New Reactors Programme
GDA Close-out for the AP1000 Reactor
GDA Issue GI-AP1000-RC-01 Revision 0 – Accident Source Terms

Assessment Report: ONR-NR-AR-16-044
Revision 0
March 2017

Figure 2: Fraction of Iodide Conversion to Iodine as a Function of pH and Concentration (Ref. 35)

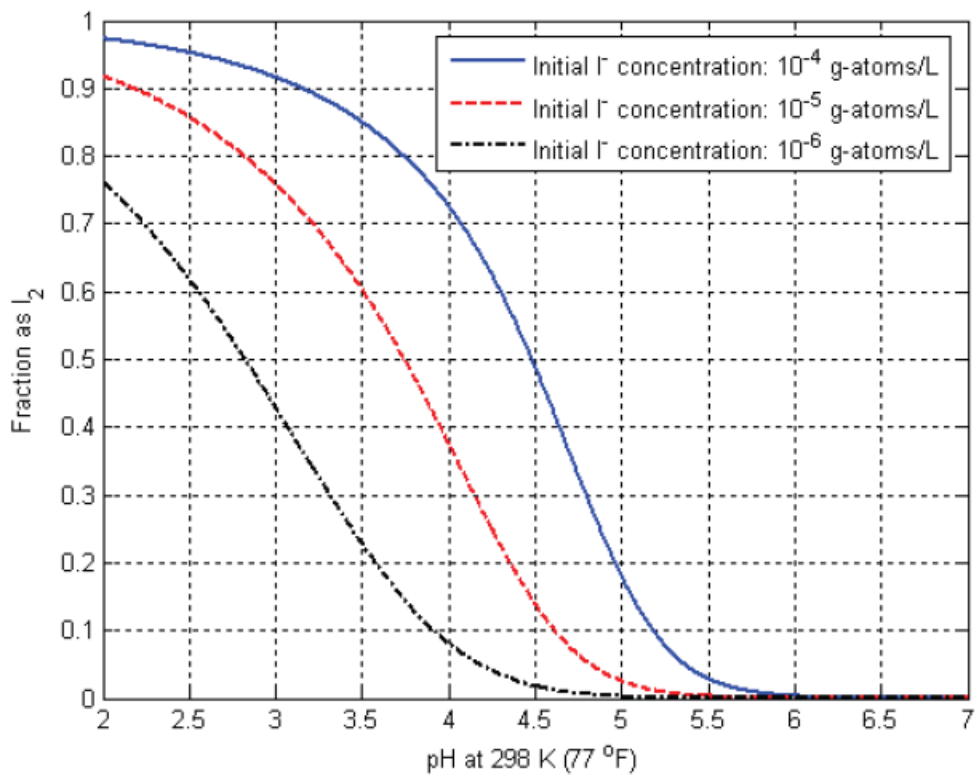
100. The other difference indicated by Ref. 21 is the increased release of iodine. The analysis in APP-PXS-M3C-036 (Ref. 34), which is based on MAAP 4.04, peaks at a CsI concentration in the IRWST of around █ kg. The same values derived from the Ref. 21 calculations showed varying amounts of dissolved CsI, which ranged from around █ kg in the most frequent scenario to █ kg in the ADS4 failure case. Applying the same frequency averaging as is used to determine the release percentages gave a value of █ kg. The effect of increasing the iodine concentration would be to make a greater proportion into volatile forms, see Figure 2 below (from NUREG/CR-5950, Ref. 35). However, the assumptions in Ref. 34 are very pessimistic for the amounts of acidic radiolysis gases produced and therefore underestimate the resultant pH; more realistic assumptions would result in a higher pH and therefore lower volatile fraction. In any case, the resultant pH and CsI concentration achieved (even assuming a higher concentration and lower pH) do not enter the region where iodine has any significant volatility. Ref. 34 is therefore conservative for the GI-AP1000-RC-01 responses.
